City Council Staff Report

Applicant: Harvest Park
Commercial, LLC

Location: Approx. 826 S
Hwy 89

Consideration of a Resolution approving the Preliminary Plat, Project Plan and Conditional Use Permit applications for the Harvest Park Condominiums Plat “A” subdivision consisting of two mixed use buildings with commercial on the ground floor and residential above located in the General Commercial (GC-1) zone.

TITLE
ARCHITECTURAL
SITE PLAN

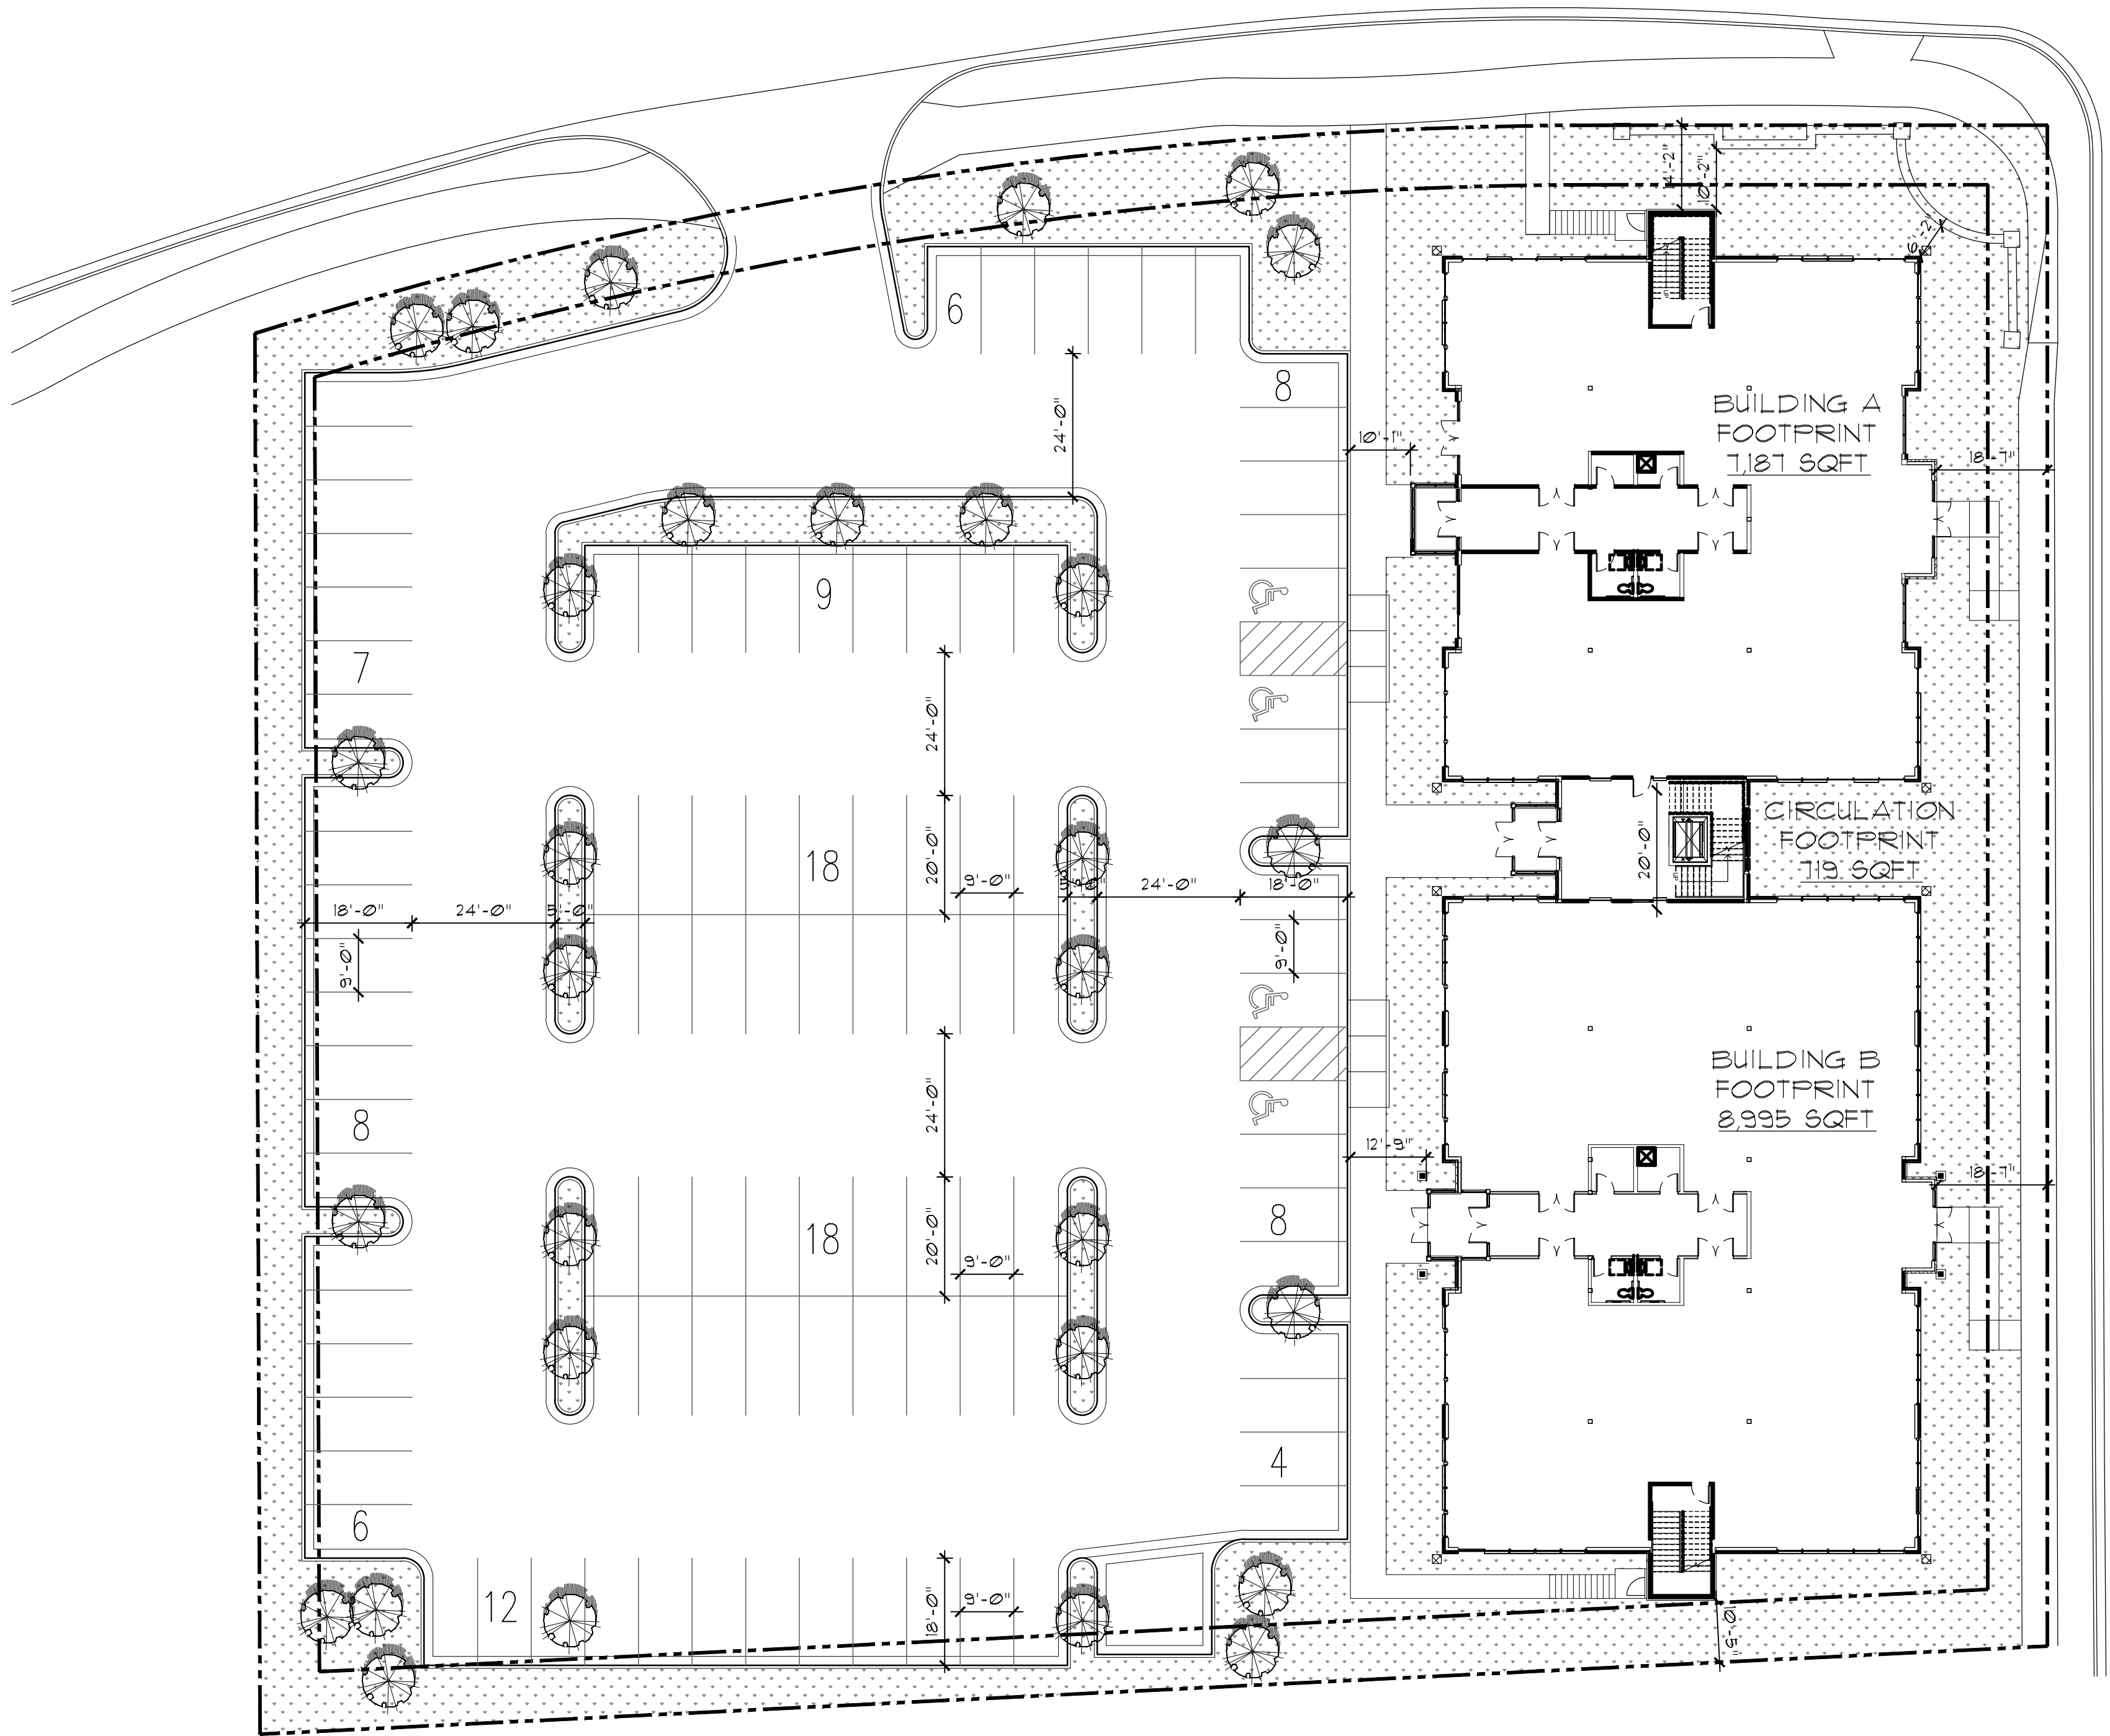
$16,182 / 200 = 81$ COMMERCIAL STALLS REQ.
 $18 \text{ RES UNITS} * 2 = 36$ RES STALLS REQ.
 $81 \times 0.25 = 20$ SHARED COMMERCIAL STALLS
 $81 + 36 - 20 = 97$ STALLS REQUIRED
104 STALLS PROVIDED

$117 \text{ REQUIRED} - 104 \text{ PROVIDED} = 13$
 $13 / 117 = 11.1\%$

HARVEST PARK CONDOMINIUMS

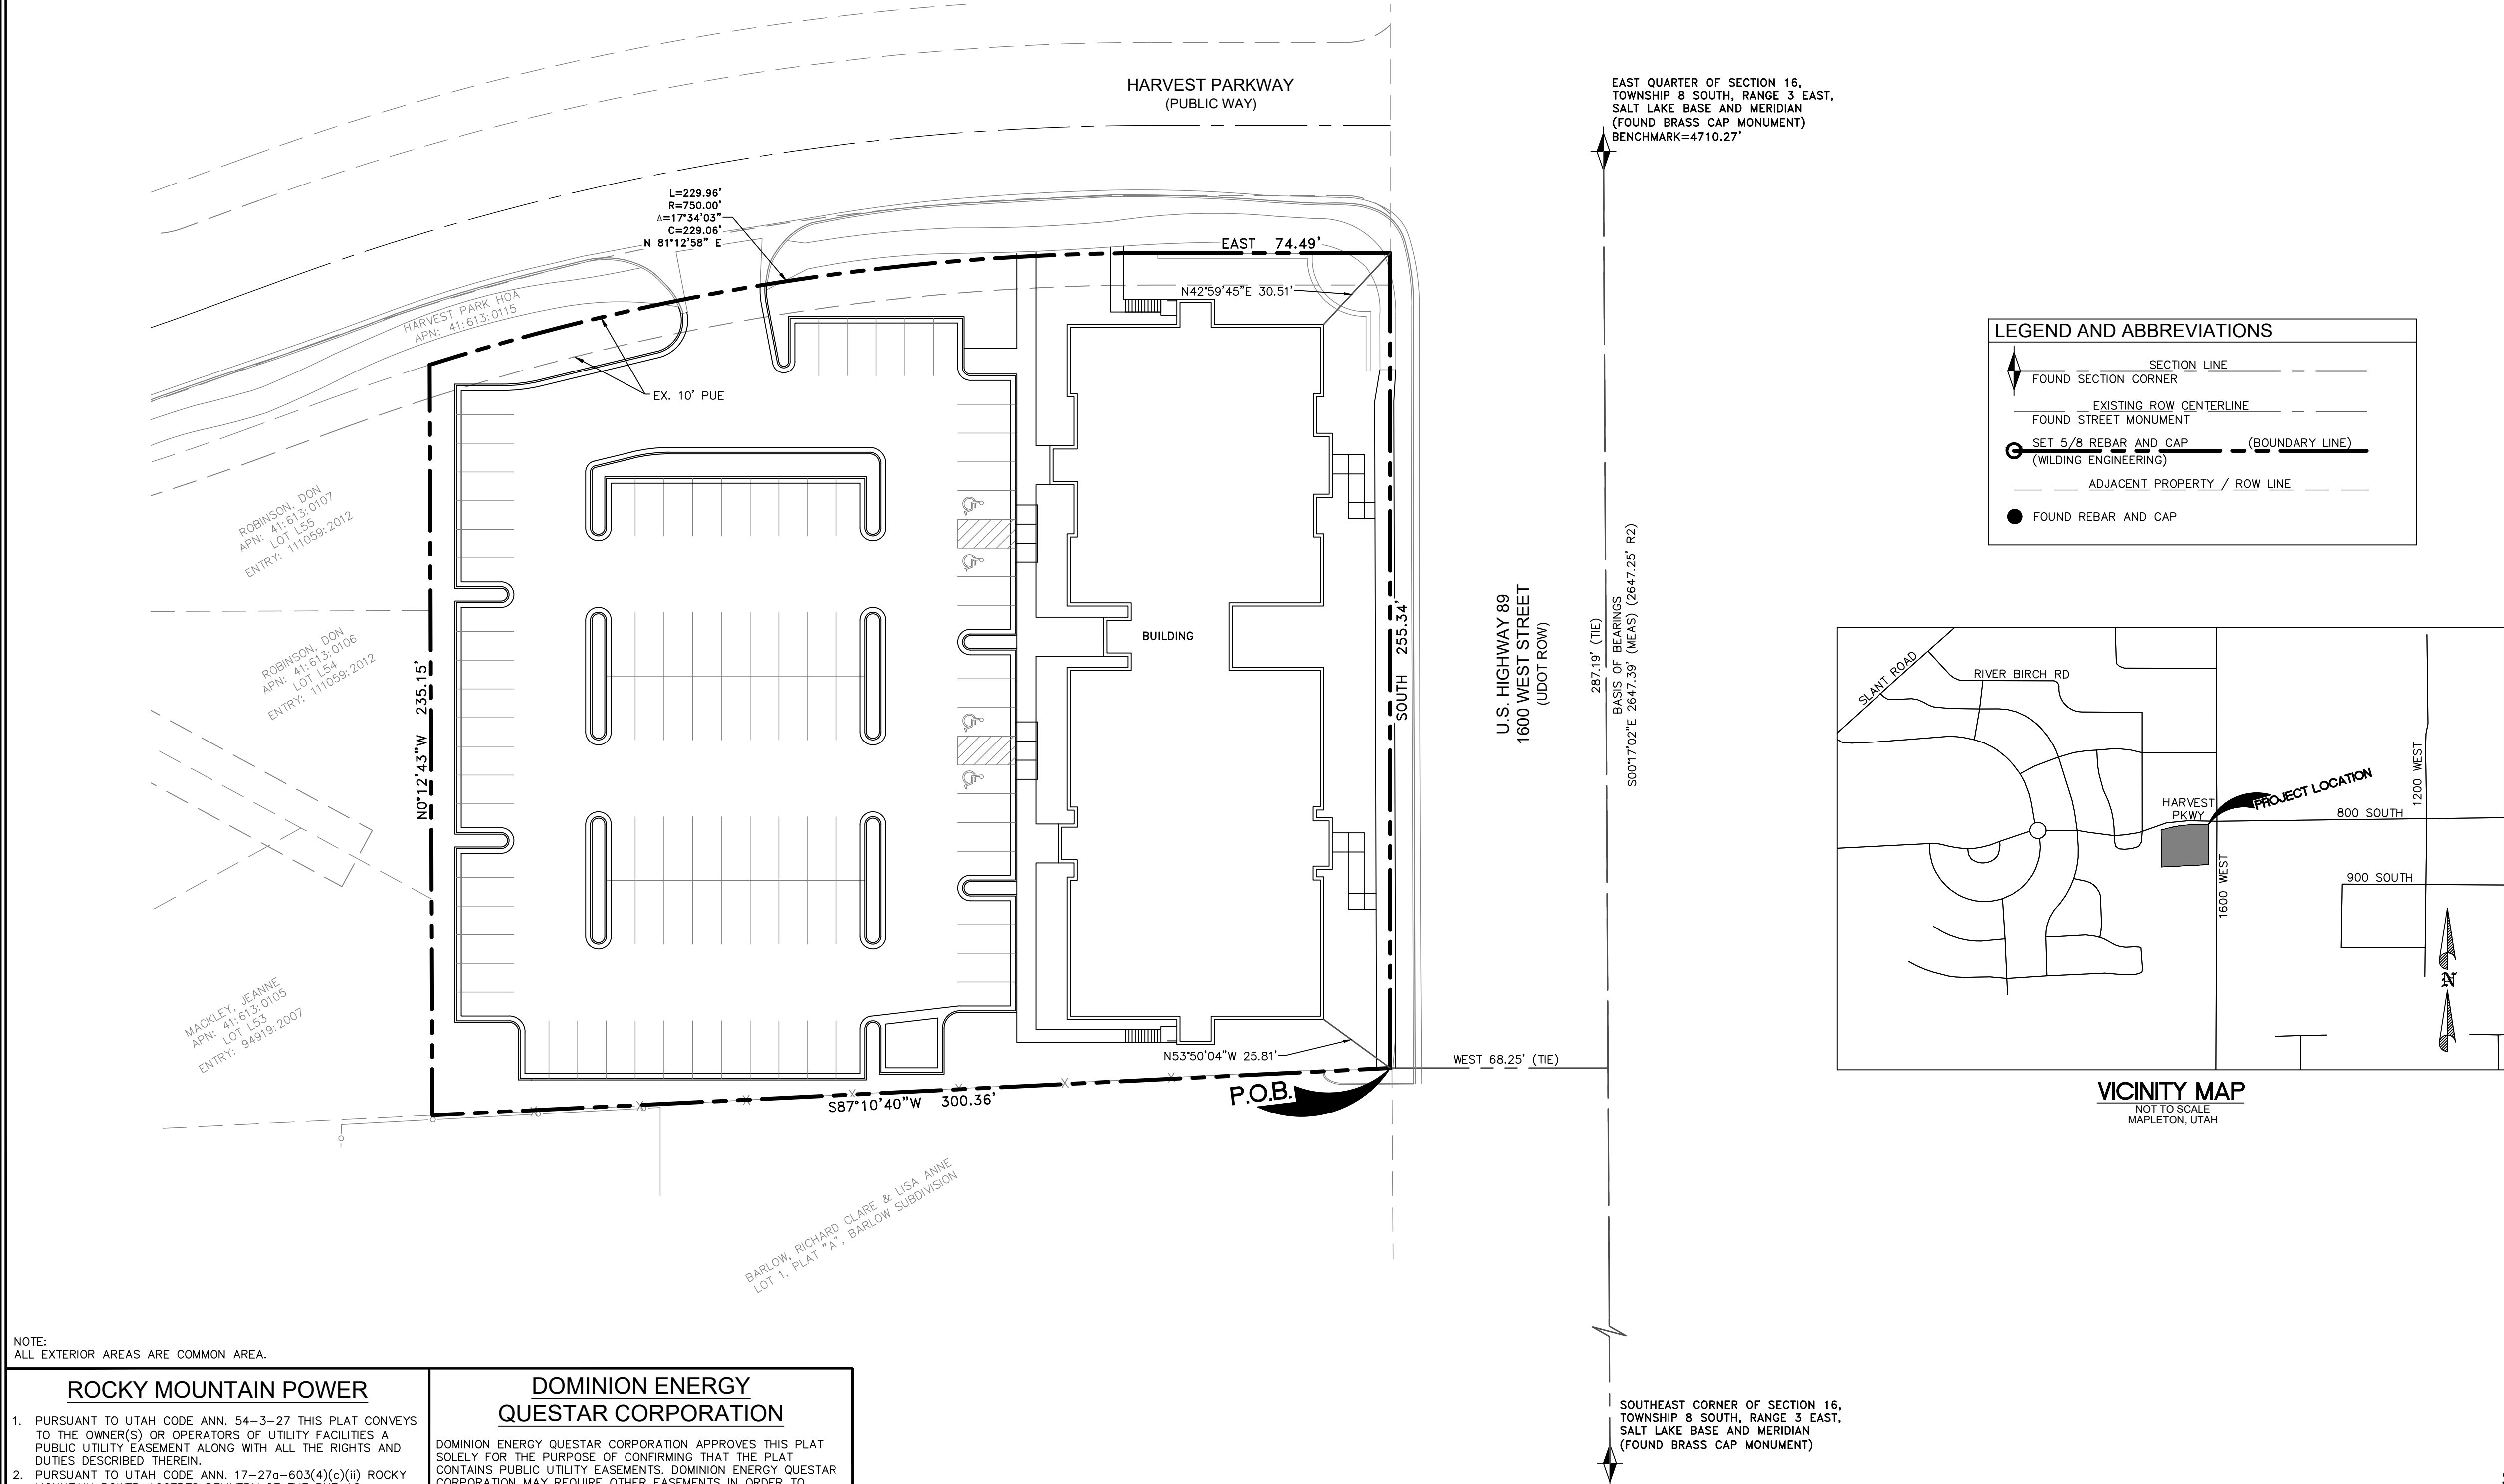
1. The plat doesn't label the parking area or area around the buildings as common area.
2. Please include the address of 826 S 1600 W next to "Harvest Park Condominiums" at the top of the first page of the plat.
3. Each unit will need its own meter. No master meters will be approved.
4. Max parking lot light pole height is 16'. Plan shows 16' but table on sheet esp100 shows it as 20'.
5. Provide verification that access issues have been resolved with Harvest Park HOA.
6. Provide a written response to the Planning Commission's questions regarding:
 - Snow removal
 - Construction access

Figure 1 US-89 / Harvest Parkway Entering Vehicle Volume Comparison

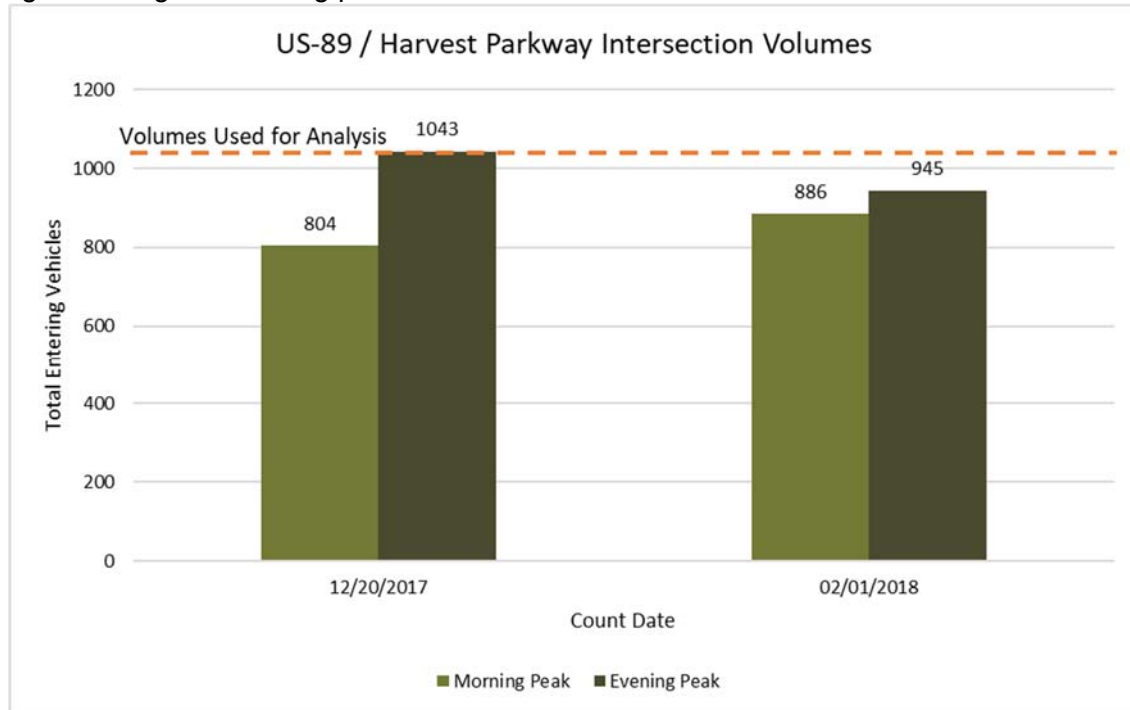
The turning movement counts were compared with the counts performed in December 2017. As shown in Figure 1, the evening peak hour entering vehicles (volume) in December was approximately 98 more than the entering vehicles in February, however, the reverse is true for the morning peak hours, e.g., the entering vehicles (volume) in December was lower than the volume in February by 82 vehicles. However, since the evening peak hour counts in December were greater than all other peak hour volumes from December or February, the peak hour analyses were completed for a "worst case" scenario, therefore, there is no need to re-evaluate the February data.

- The evening peak hour counts collected in December 2017 are higher than all other peak hour counts from December 2017 or February 2018. These volumes were used for the original analysis and, therefore, represent the “worst case” traffic volume conditions for the study area. Therefore, it is not recommended that additional analyses be completed for the proposed Harvest Park Commercial project.
- Though the morning and evening peak hour volumes were approximately equal on Harvest Parkway based on the tube counts, the evening peak hour volumes at the Harvest Parkway / US-89 intersection are much higher than the morning peak hour volumes.
